SERVICE BULLETIN

B-021A

SAFETY RECALL CODE 0814 - FUEL TANK RETENTION SYSTEM

Figure 1. Original Fuel Tank Mounting Arrangement

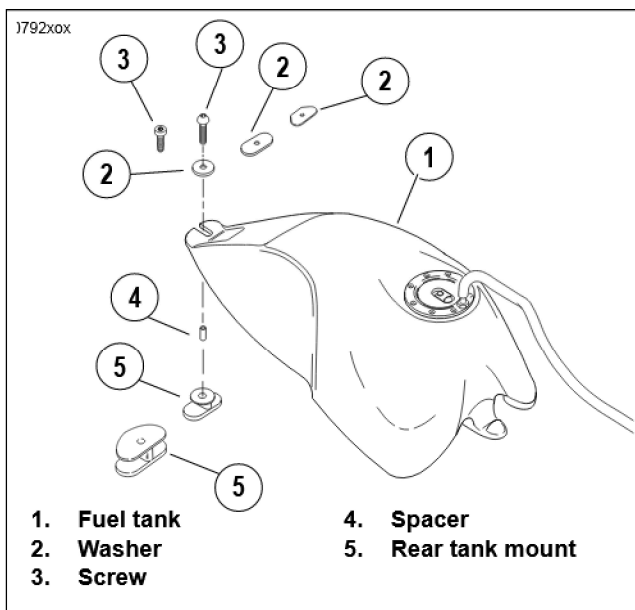
See Figure 1. Vehicles being serviced will have varying combinations of tank mounting parts. Once removed, Items 2, 3, 4 and 5 are to be discarded.

- See Figure 1. Remove and discard fuel tank mounting screw (3) and washer (2).
- While securely holding fuel tank, carefully slide rear tank mount (5), with spacer (4), to the rear of the vehicle and away from the tank. Discard mount and spacer.

Figure 2. Retention Plate with Decal

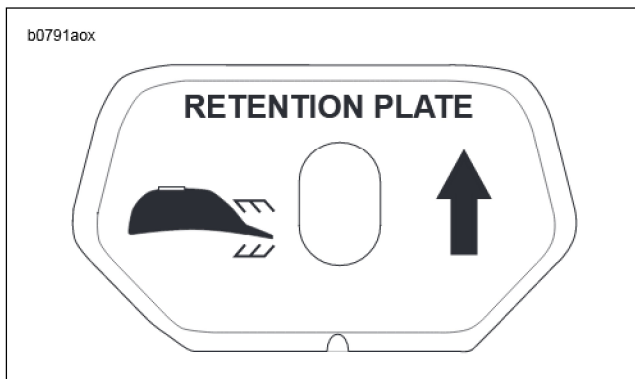
See Figure 2. The retention plates have decals on them showing the position and direction that they are to be mounted. Also, they have a V-shaped notch on the shorter straight side which must face to the rear of the vehicle.

Figure 3. Bottom Plate

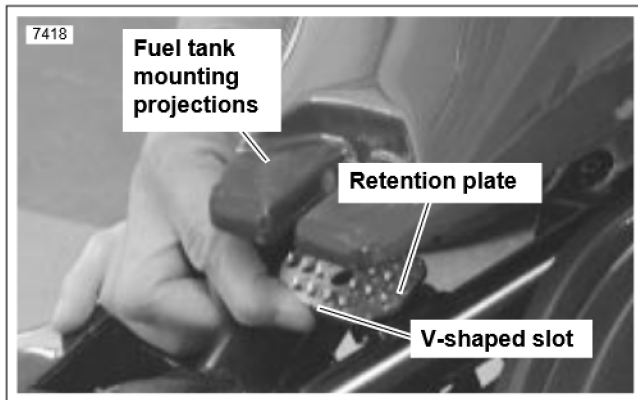
- S1/S1W/S3/S3T Models:** See Figure 3. Carefully raise the back of the fuel tank and place a mounting plate and a retention plate in position on the frame. Make sure shorter straight side of both retention plate and mounting plate face to rear of vehicle.
- M2/S2/S2T Models:** See Figure 3. Carefully raise the back of the fuel tank and place a retention plate in position on the frame. Make sure shorter straight side of retention plate faces to rear of vehicle.
- Carefully place the fuel tank onto the lower retention plate.

Figure 4. Final Assembly

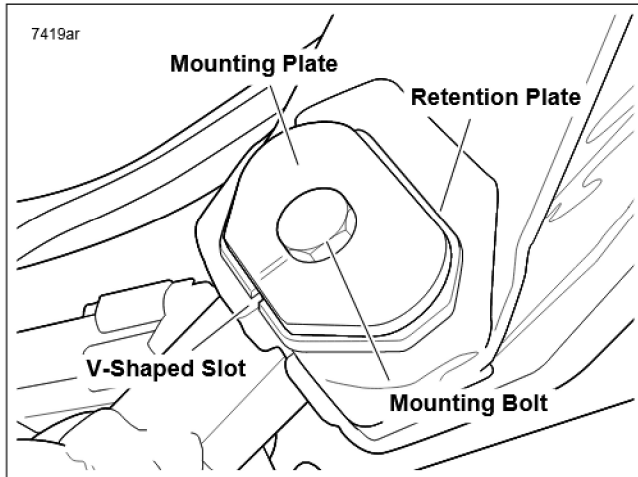
- See Figures 4 and 5. Place the remaining retention plate and mounting plate in position on top of the fuel tank rear mounting projections. Make sure shorter straight side of both retention plate and mounting plate face to rear of vehicle.
- See Figure 5. Install new mounting bolt (4) and tighten to 18-23 ft-lbs. (24.4-31.2 Nm).
- Wait five minutes and tighten bolt again to 18-23 ft-lbs (24.4-31.2 Nm).
